Minutes of T11.1 HIPPI Ad Hoc Working Group
May 12-13, 1998
Mountain View, CA

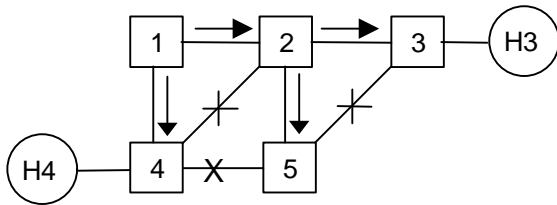
The squares are HIPPI-6400 switches, the circles are hosts, and the arrows mark the 802.1d spanning tree that results from using the switch numbers. The links marked with "X", while functional in a physical sense, are pruned in the spanning tree algorithm and not usable. Hence, the only path from H3 to H4 is 3-2-1-4. The path 3-5-4 is not usable, even though it is shorter.

1. Find a path from H3 to H4 without it being a static table, e.g., allow switches to be added/removed and the routing tables to be updated without manual intervention.
2. Allow optimal paths, e.g., 3-5-4.
3. Automatically find an optimal path for all traffic.
